**Re: Mario & Ruth De Hoyos  
Ridgeview Oaks-West Lot 39  
Application for Permit for Authorization to Construct an On-Site  
Sewage Facility (OSSF)**

RE: Residential Septic System @ 1081 Rainbow Dr, Spring Branch, TX 78070  
(Permit # 118365)--**Spray set back variance request**

RE: Residential Septic System @ 1081 Rainbow Dr, Spring Branch, TX 78070  
( Permit # 118365)--**Water line Variance Request**

OSSF Design for RIDGEVIEW OAKS WEST, LOT 39

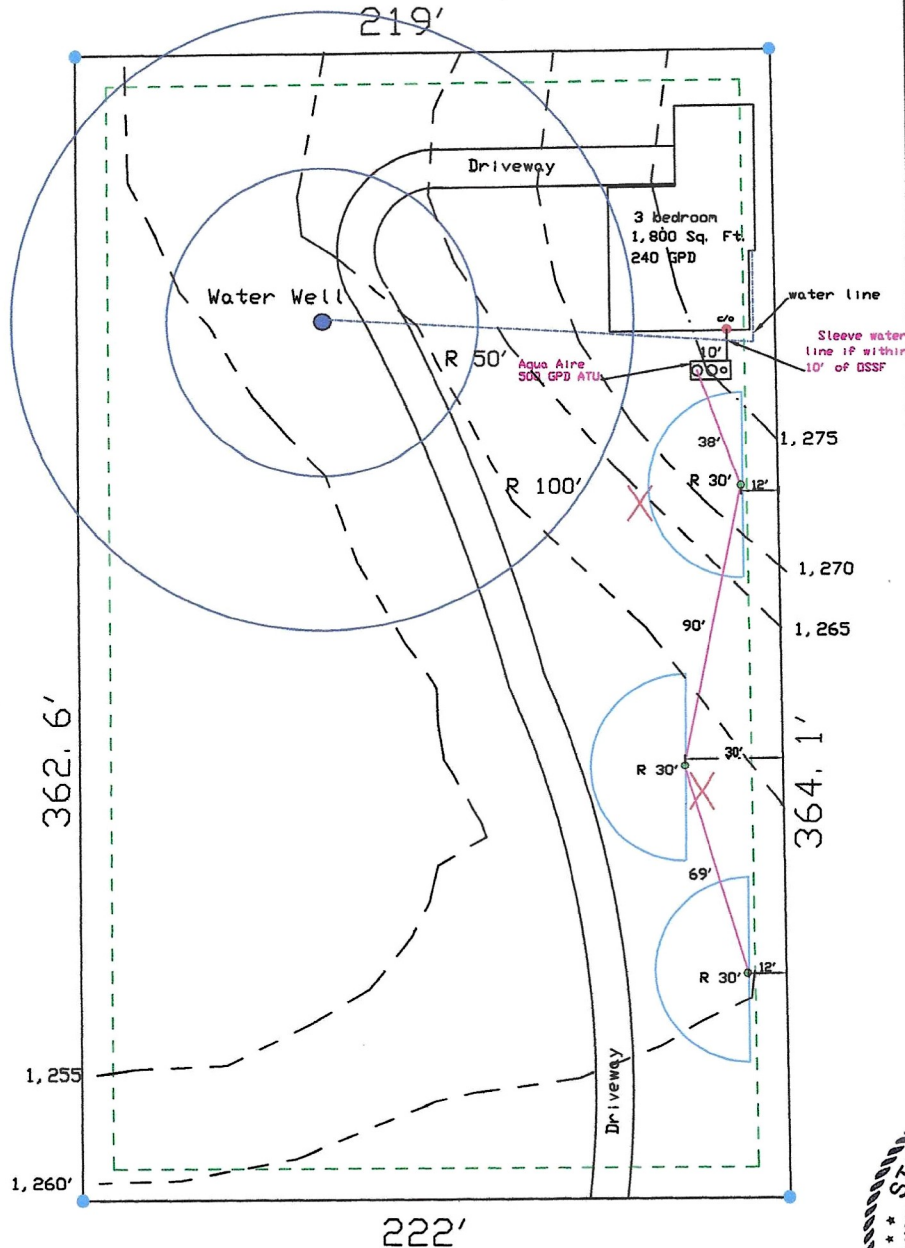
- ✓ 1. The owner name on the permit application must match the owner name as described on the recorded deed.
- ✓ 2. Both property owners must sign the permit application.
- 3. The subdivision name on the permit application must match the subdivision name as described on the recorded deed.
- 4. The 2 year initial maintenance contract must indicate that the start date of the contract is the date the License to Operate is issued.
- ✓ 5. There are discrepancies within the planning materials on the blank of ATU. Written planning materials, pump tank detail, and manufacturer sheet have Aqua Aire but the design indicates Clearstream.
- ✓ 6. Maintain required 20 ft. setback from the edge of the spray areas to the property line.
- 7. Revise as needed and resubmit.

Good afternoon, I have rearrange the spray head configuration and have show the contours. I have also shown the distances from the spray to the edge of property line. Please let me know if anything else is needed and thank you for your time.

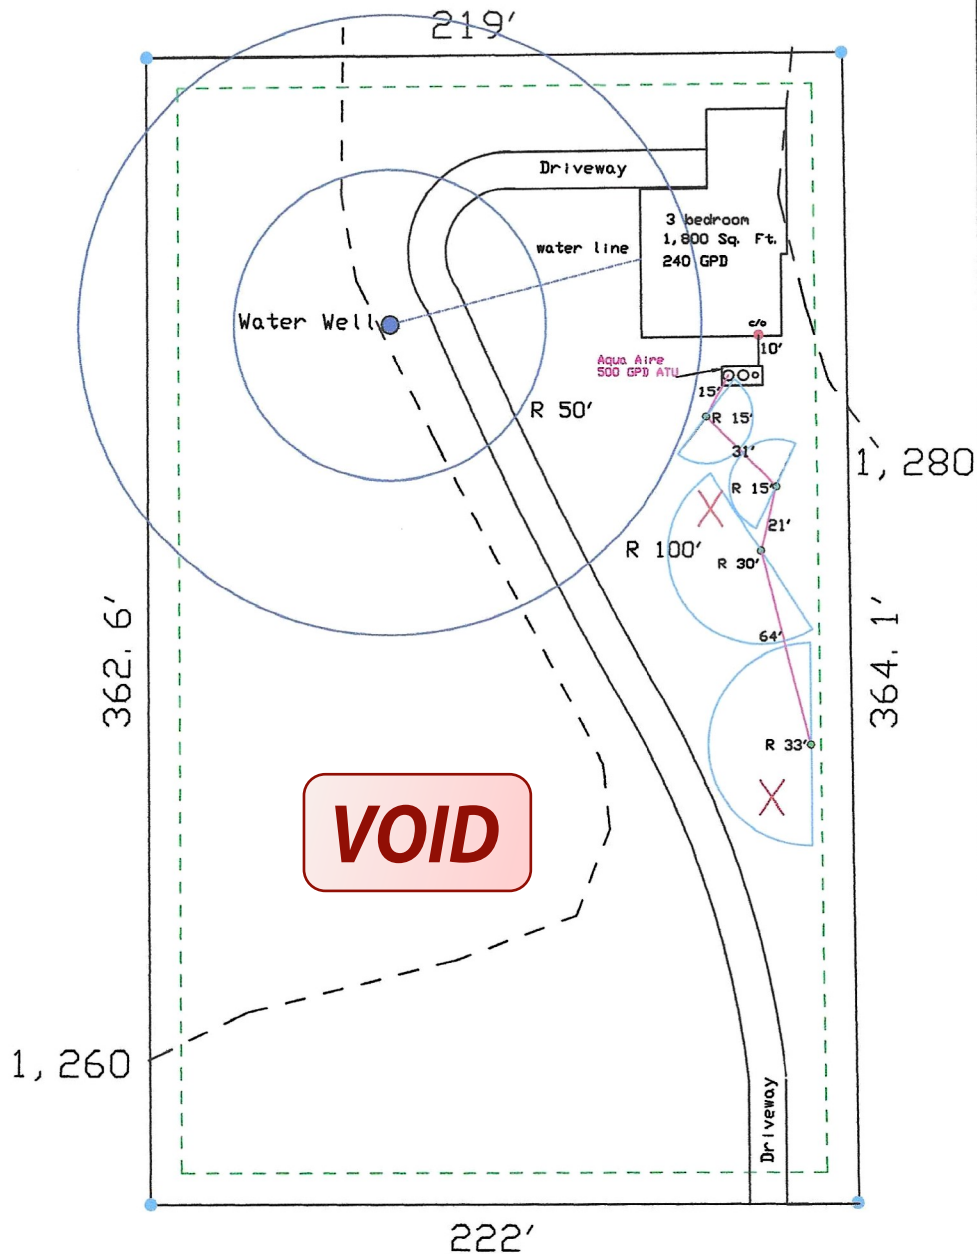
- ✓ The variance request must be signed.
- ✓ The permit application indicates Ridgewood Oaks – West. The correct legal description is “Ridgeview” Oaks-West. A clearer copy of the application is also needed.
- ✓ Signature needed on the design.
- ✓ Maintenance contract should indicate the start date is the date of the “License to Operate” instead of LTO.
- 5. Revise as needed and resubmit.

Good Day Brenda, please see attached design revision, the configuration, square footage and number of heads have changed. I have revised the 2nd page of the application as well as the calculation and design pages. Thanks and have a good day.
